From: Mason Xie <Mason@AseiiCorp.com>
Sent: Wednesday, December 15, 2021 6:58 PM
To: 'Kevin Johnson'; 'Jordan Gray'
Cc: 'Vanden Fehmerling'; drpatel@primarycaremedic.com; 'Todd Gray'; 'Bryan Plaskett'
Subject: RE: CYM Lake City Submittal 31000-1_Geopier SD and Calcs.pdf
Attachments: Courtyard Marriott (Lake City, FL) 21-007_VR_REV1_eSealed.pdf

COURTYARD MARRIOTT

VIBROREPLACEMENT (VR) STONE COLUMNS

| SHEET NUMBER: | ET-1.0 |

3 TYPICAL VIBRO REPLACEMENT LAYOUT

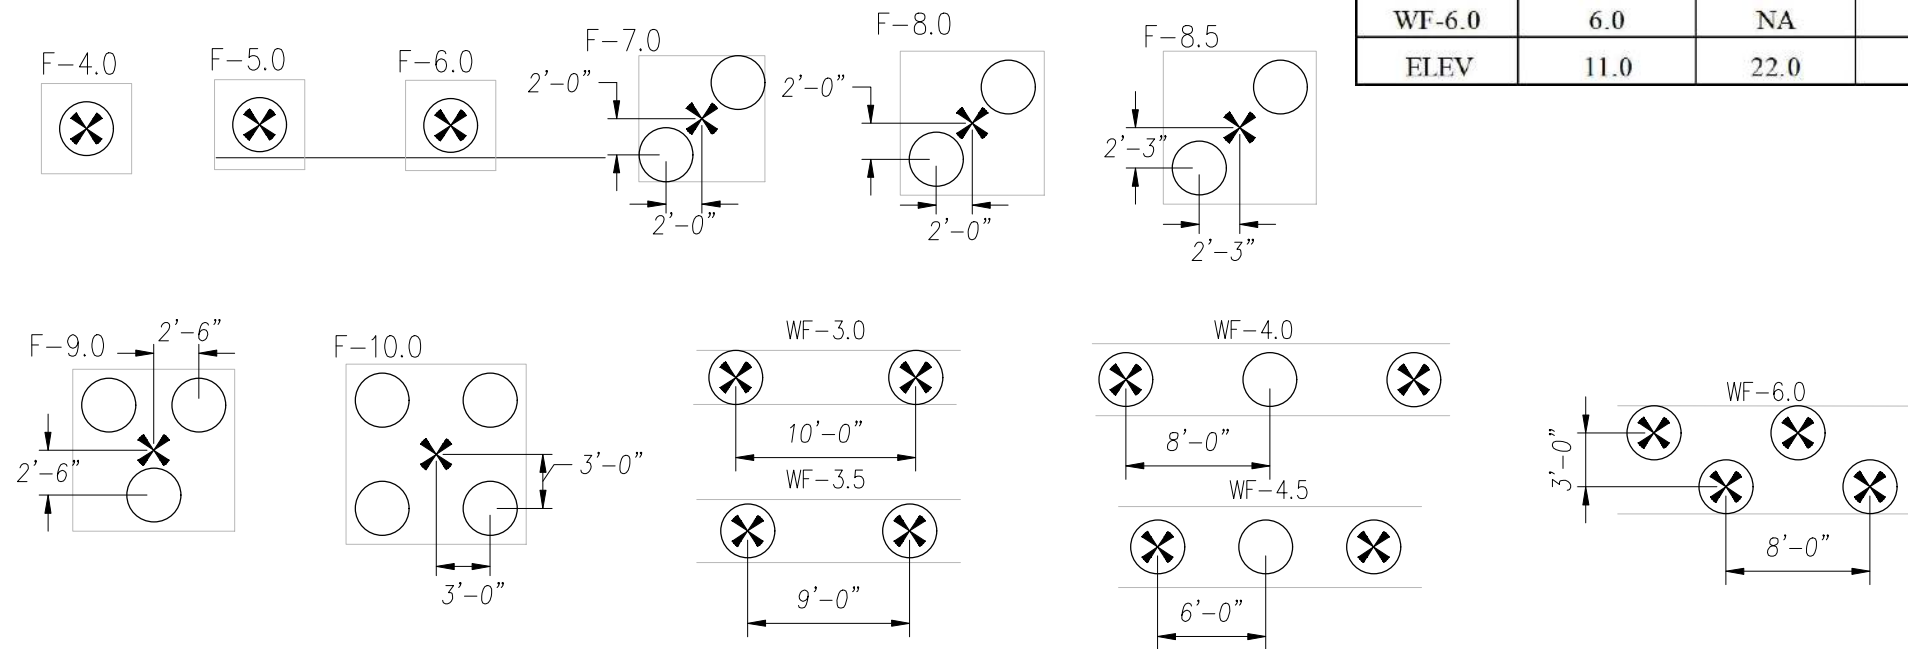
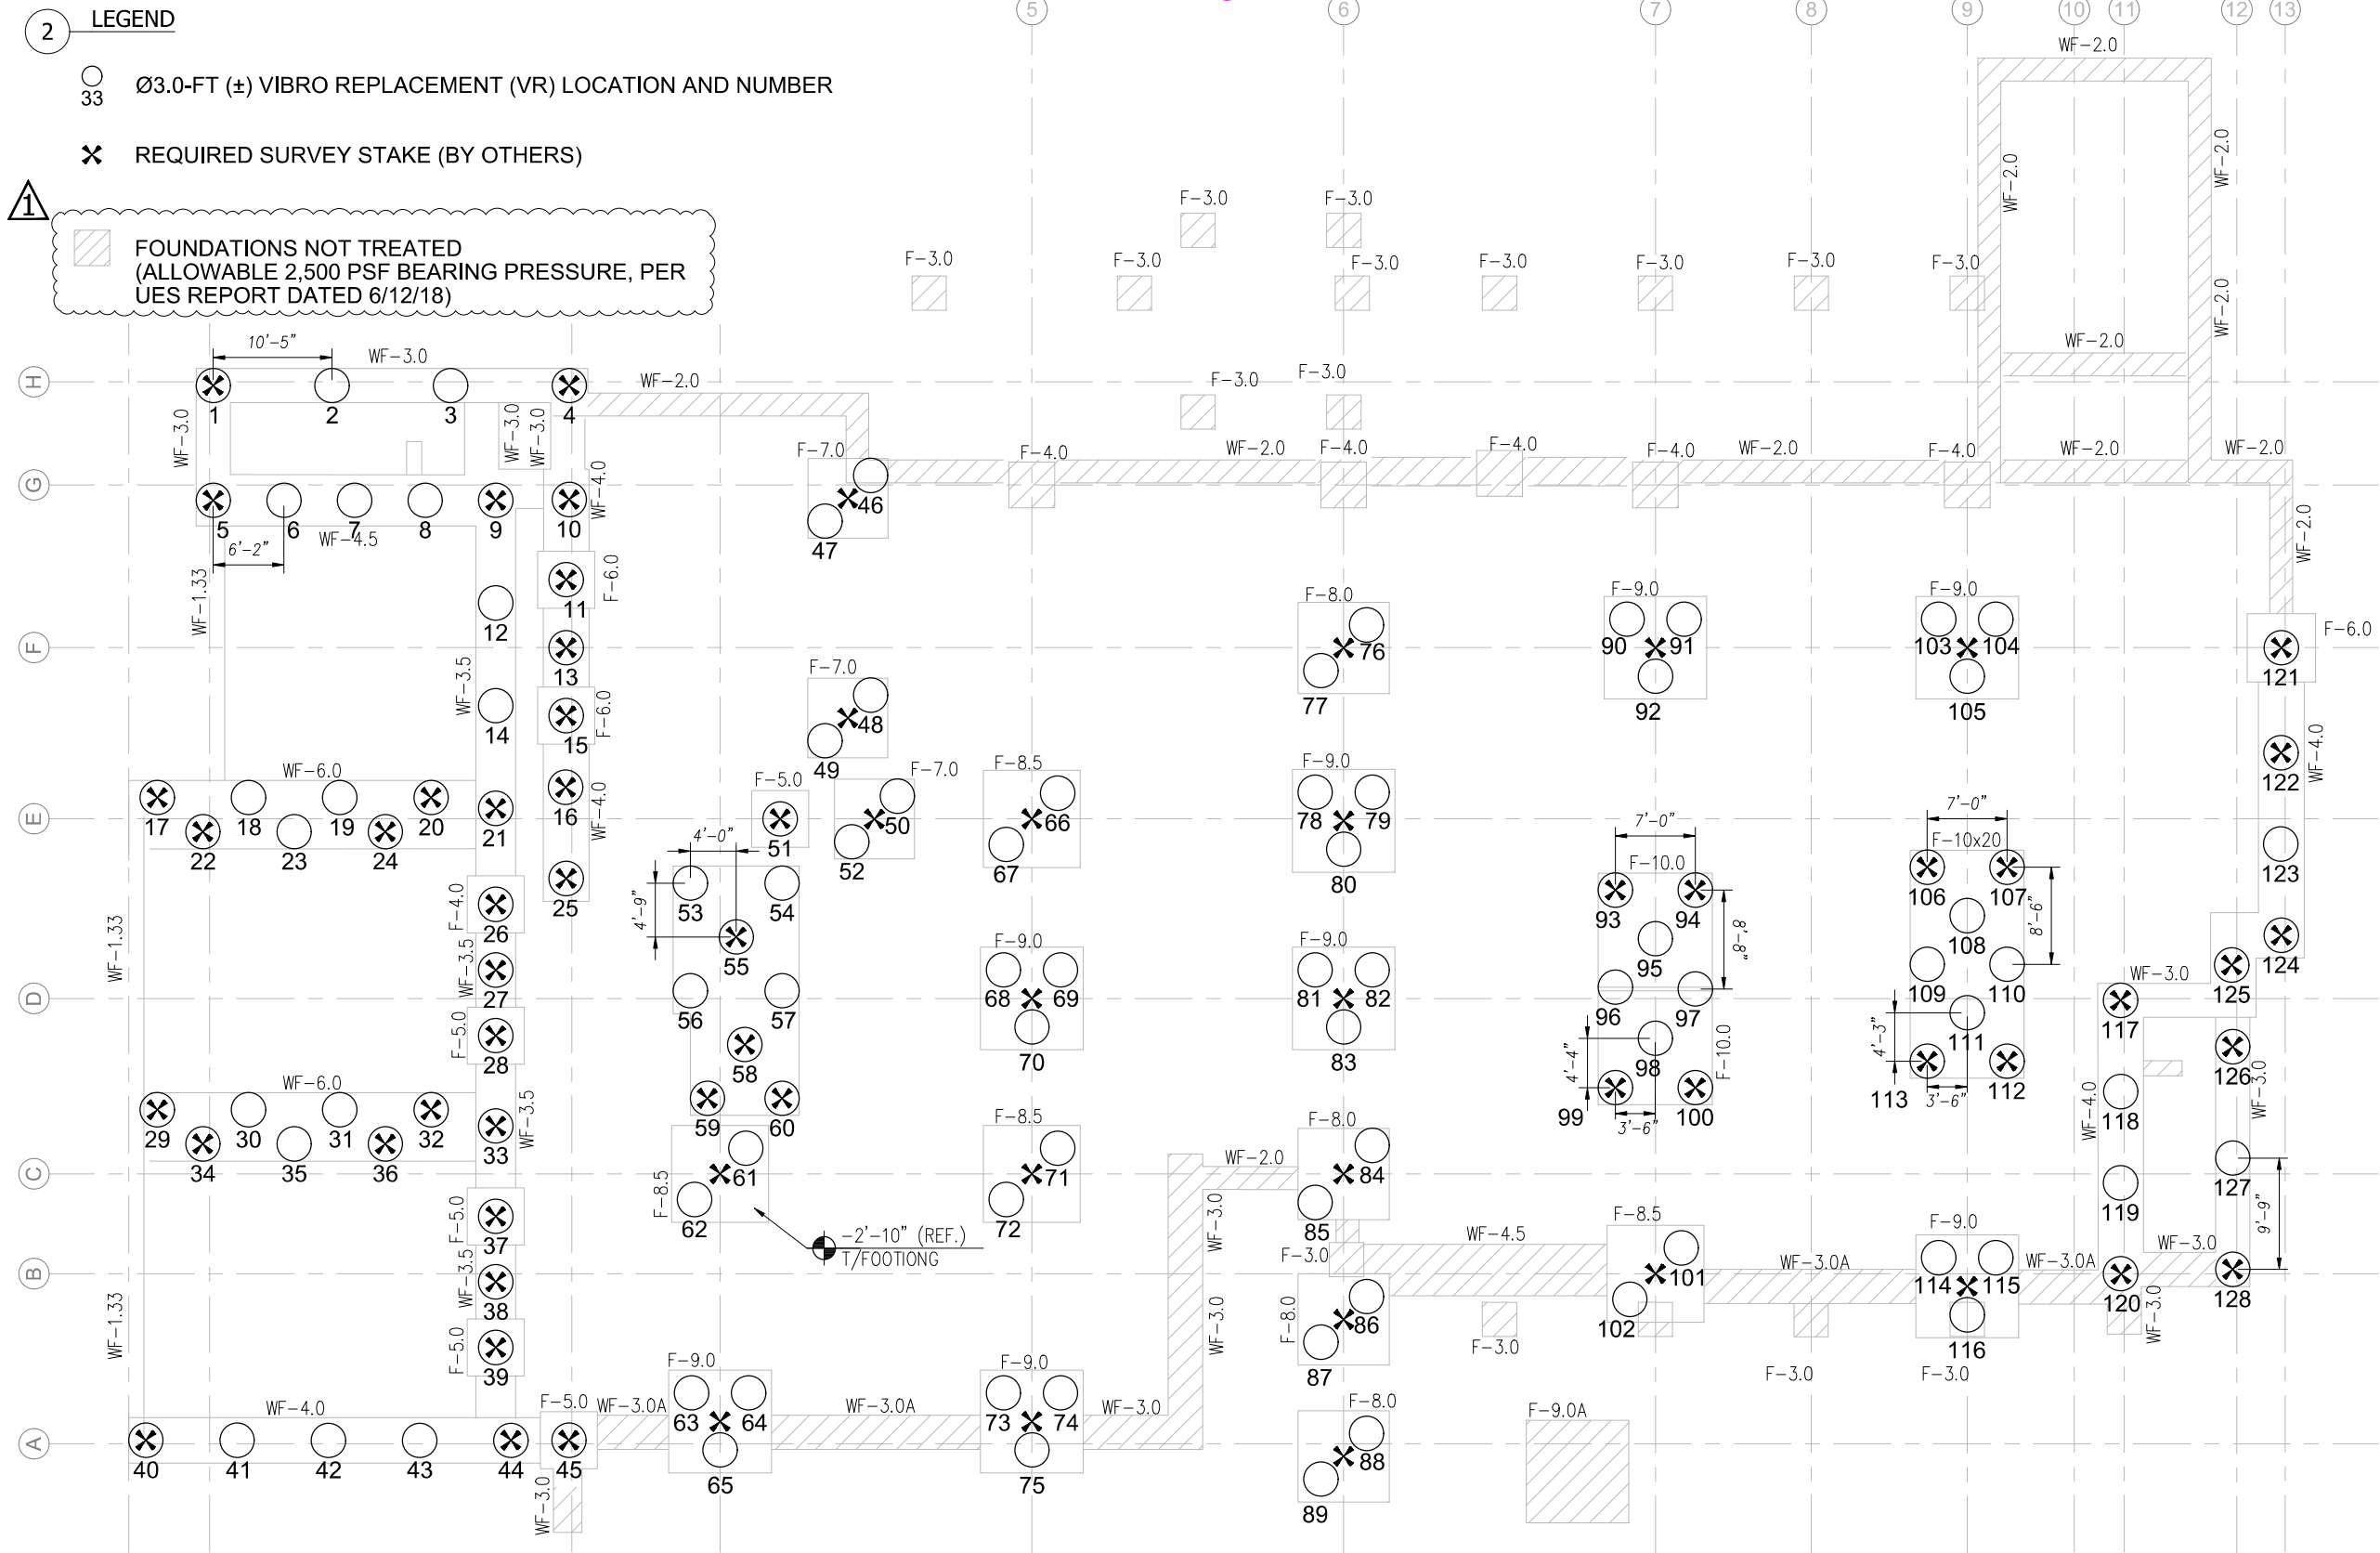
Attached are the revised shop drawings along with the soils report which recommends shallow foundation up to 2,500 psf without ground improvement. Please let us know if any of the hatched footings are expected to have more than 2,500 psf average bearing pressure (localized pressures due to transient loads may be higher).

I spoke with Mason on the phone and per our conversation, Earth Tech will resubmit the 2021 drawing with clarification for the untreated footings and reference to Universal's 2018 report (attached) which specifies a bearing capacity of 2,500 psf for untreated foundations.
I will get this sent out tomorrow morning.

FOUNDATIONS NOT TREATED
(ALLOWABLE 2,500 PSF BEARING PRESSURE, PER
UES REPORT DATED 6/12/18)
